WETLANDS PERMIT MODIFICATION PLAN

PLAT MAP 67, LOT 106
 ZONING DISTRICT R-40
 RESIDENTIAL DISTRICT 40,000 S.F.
 0 COTTONTAIL DRIVE
 PORTSMOUTH, RI

ONSITE WASTEWATER TREATMENT SYSTEM PLAN

DRAWING NUMBER
C1
 SHEET: 1 OF 3

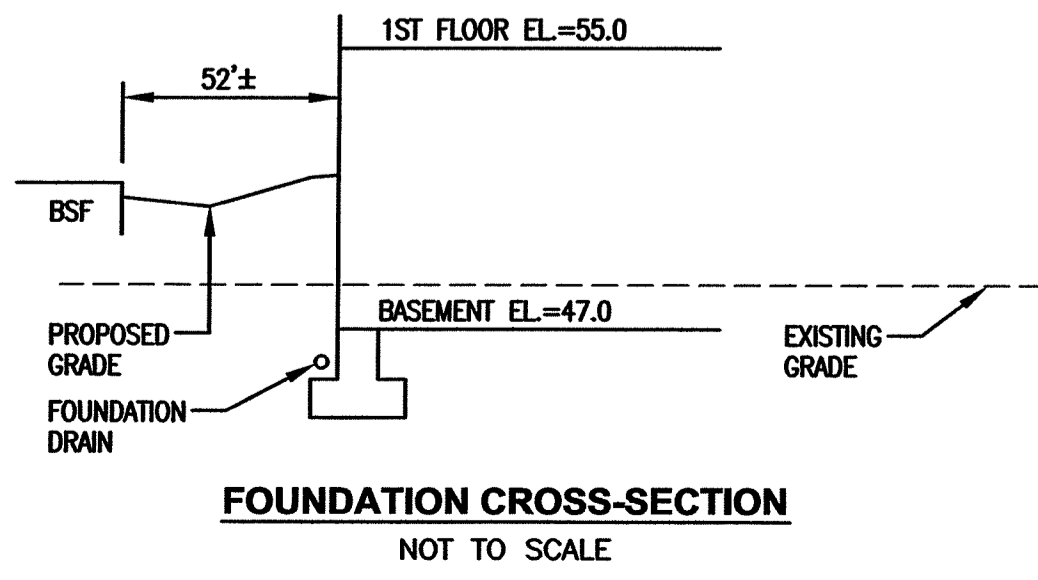
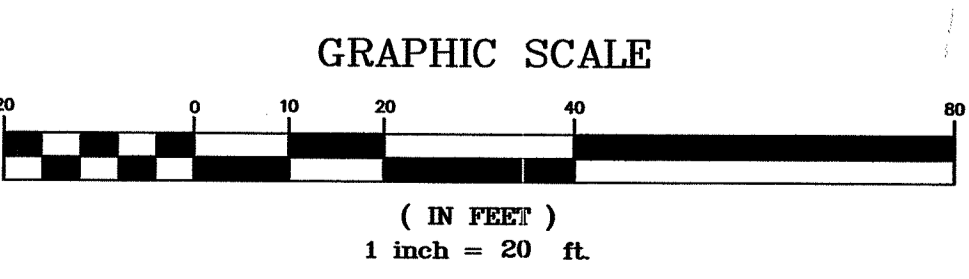
Relocate Buffer Markers to Riverbank wetland, per RIDEM Condition No. 19.
